**Re: Special Use Permit & Site Plan Review Comments
Proposed Dollar General
NYS Route 7
Town of Duaneburg, New York**

DUANESBURG DOLLAR GENERAL – Stage II Comments

**Re: Response to Comments Summary
Proposed Retail Store
NYS Route 7**

DRIVEWAY 'AHEAD' SIGN

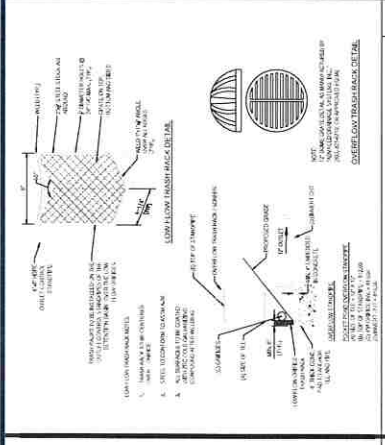
Add driveway warning sign WB prior to entrance.

NYSDOT SHOULDER RECONSTRUCTION

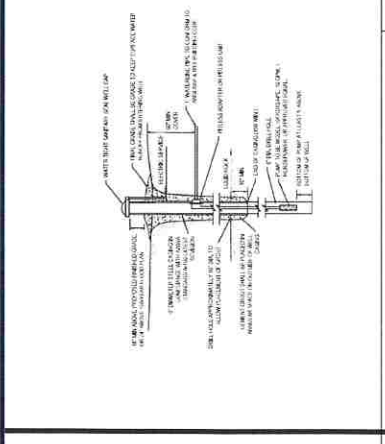
8. Add shoulder reconstruction detail showing Item numbers 404.098201(1.5" Top), 404.198901(2.5' Binder), 404.378901(2 – 3" lifts Base), 304.12(subbase), 407.0102(Tack coat), 418.7603(joint adhesive), and 520.09000010(saw cutting asphalt).

TYPICAL PAVEMENT SECTION

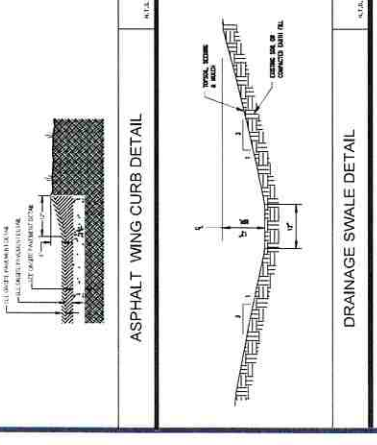
9. Sheet No. C-901, asphalt pavement detail, add NYSDOT Item numbers. 404.098201(1.5" Top), 404.198901(2.5' Binder), 304.12(subbase), 407.0102(Tack coat) and 304.12(subbase).

GRADING & DRAINAGE PLAN
 SHEET TITLE
 SHEET NUMBER
C-401

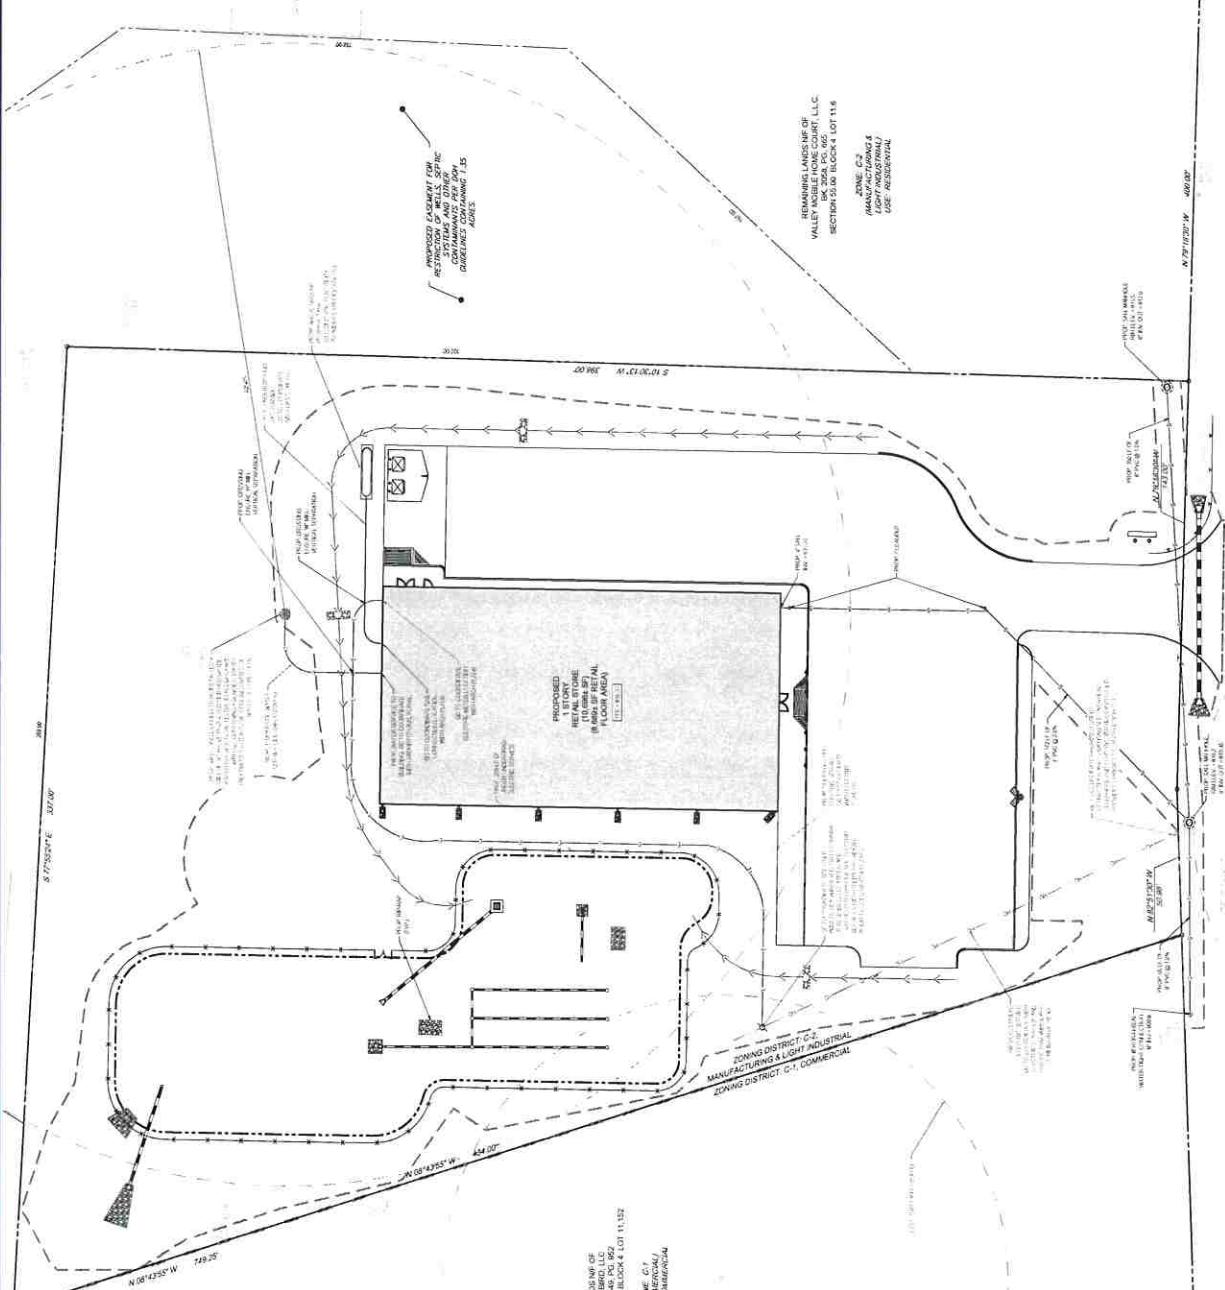
Comment 1: Please revise proposed grading to tie out the existing site elevations at the access drive and in the area of the detention pond similar to the Grading Plan that is included in the SWPPP.

Comment 2: Please show a positive slope of a minimum of 0.5% on the outlet pipe for the dry pond.

Comment 3: Please provide a slope stabilization treatment for the 1:2 slope between the northwest corner of the building and the drainage swale.

The proposed grading has been revised to tie out to the existing site elevations around the access drive and the area of the detention pond.

The outlet pipe from the dry pond was revised to have a slope of 0.5%.

Enkamat has been proposed near the northwest corner of the building in order to provide slope stabilization.

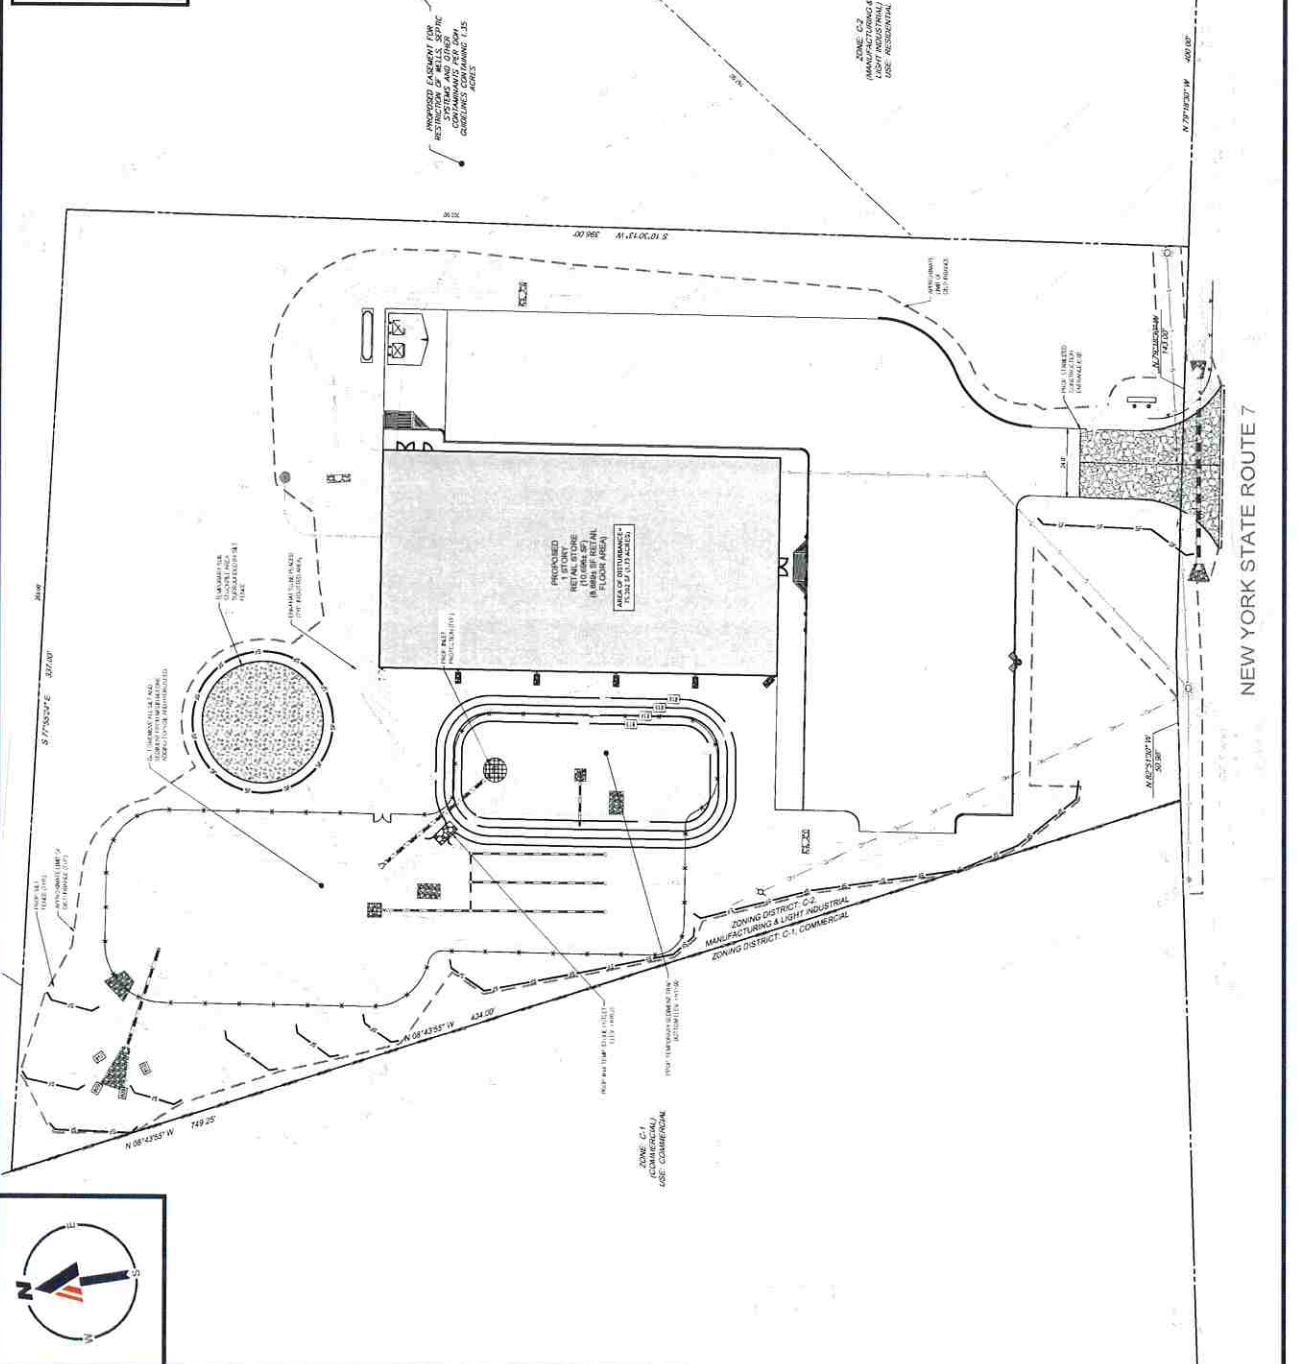
Comment 2: "Soil Erosion & Sediment Control Plan", Sheet C-601- Label Sediment Trap location and specify outlet device. It appears as if it is currently labeled "Temporary Settling Basin".

The Sediment Trap label has been added to replace the Temporary Settling Basin label and the outlet device has been specified/labeled.

DETAIL SHEET
C-904
 REVISION 5 - 10/20/22

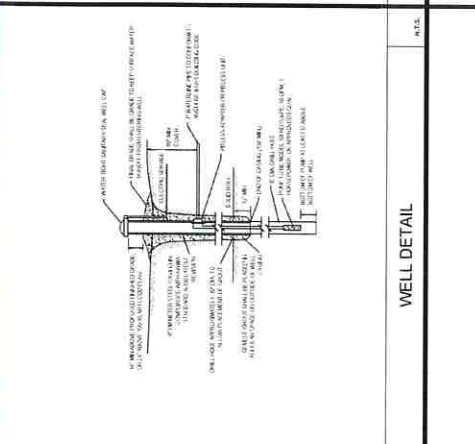
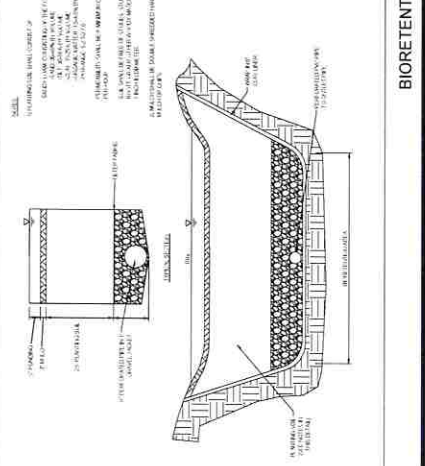
Comment 1: Please include bioretention cross section detail.

Comment 2: Please include well detail.

A bioretention cross section detail has been added to Detail Sheet C-904.

A well detail has been added to Detail Sheet C-904.

C-301

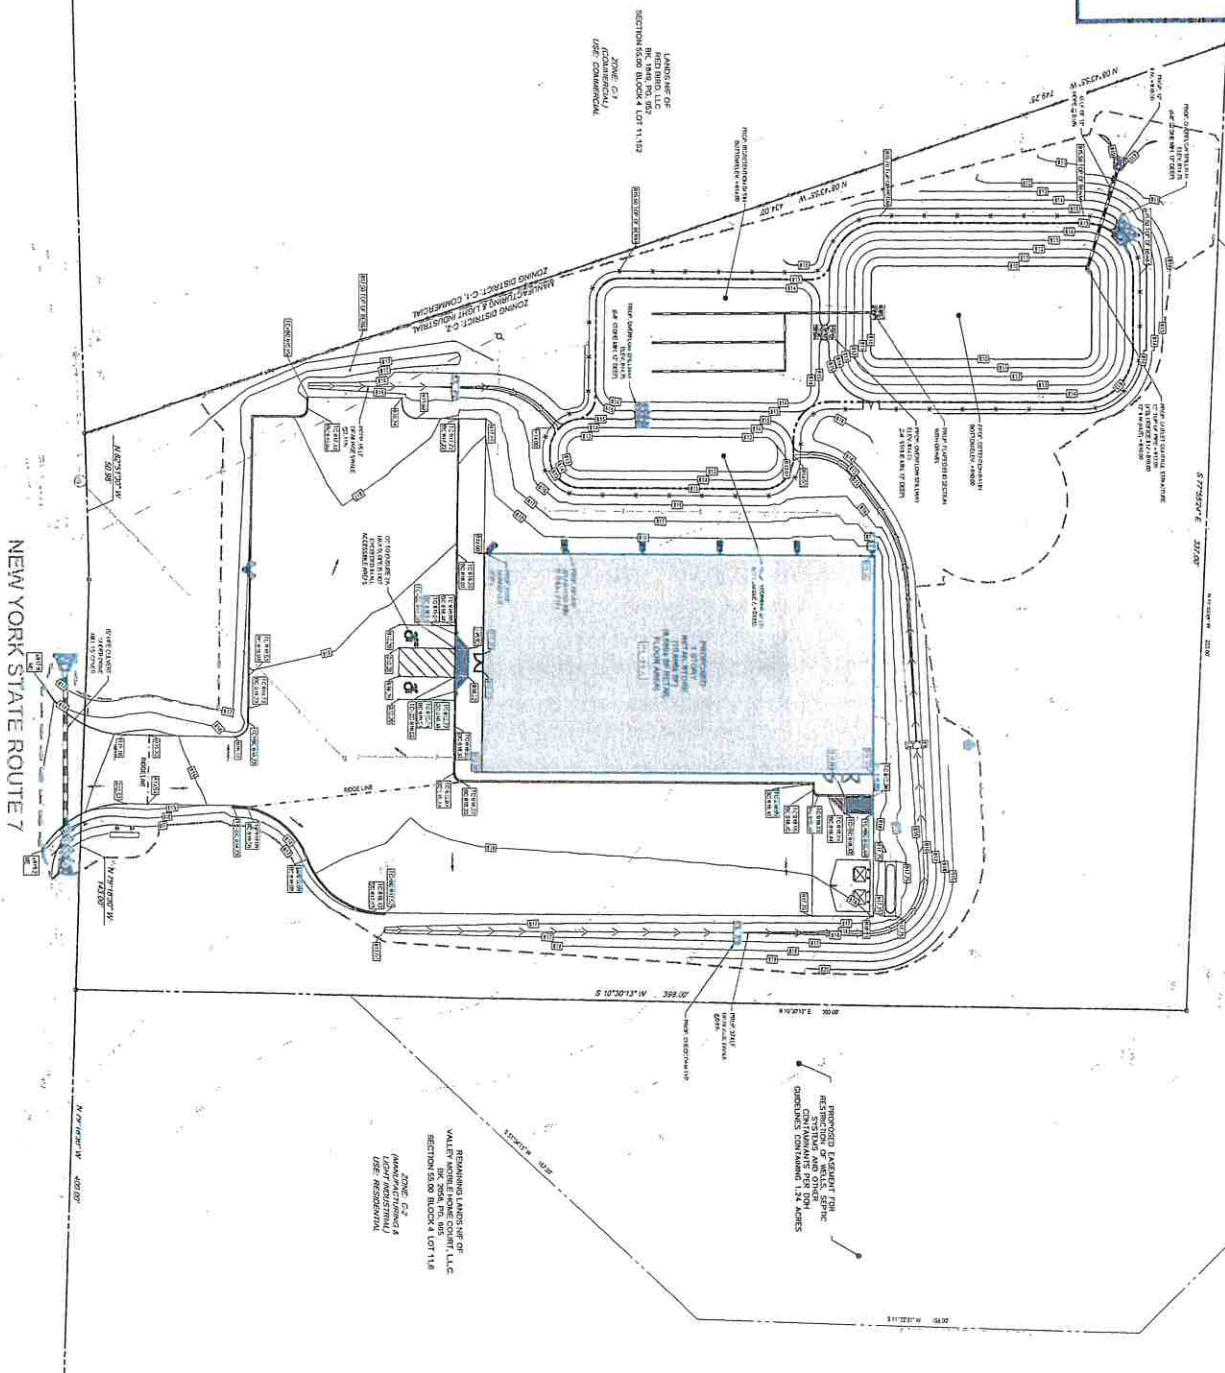
Comment 1: Verify the intersection sight distances and stopping sight distance for the proposed driveway in accordance with NYSDOT Standards. A NYSDOT commercial driveway approval will be required.

Comment 2: Provide location of fire and other emergency zones per Town Code Section 14.6.1.4.13.

Comment 3: Provide location, and design, of all energy facilities per Town Code Section 14.6.1.4.14.

Comment 4: Verify proposed signage will meet requirements of Town Code Section 13.4.7, "Commercial (C-1) & Light Industrial (C-2) Sign Regulations."

Comment acknowledged. Sight distance measurements have been taken from the proposed driveway location and measurements are provided on the site plan. This data has been provided to DOT as well.

Comment acknowledged. The proposed electric location is shown. Energy facilities are not proposed.

LANDSCAPE PLAN
 SECTION 35.00, BLOCK 4 LOT 11.03
 ZONE: C-1
 LDC: COMMERCIAL

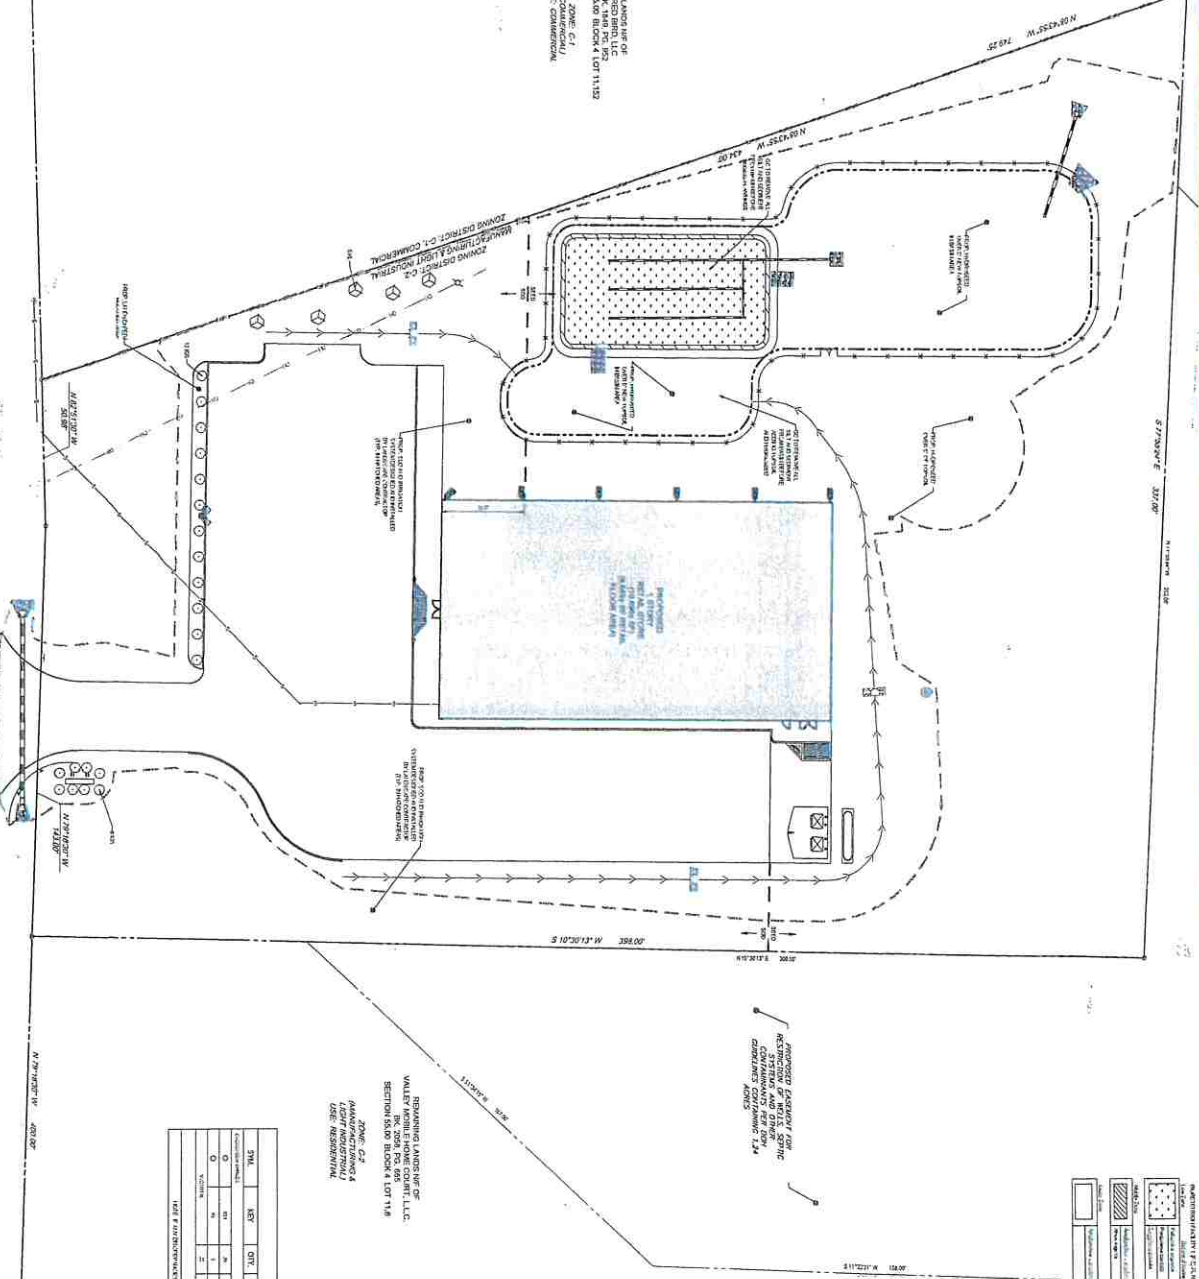
Comment 3: "Landscape Plan", sheet C-701 – Include table of bioretention plantings on this sheet or on the "Detail Sheet", C-904.

Comment acknowledged. The table of proposed plantings for the bioretention area is included on the Landscape Plan in the upper right-hand corner.
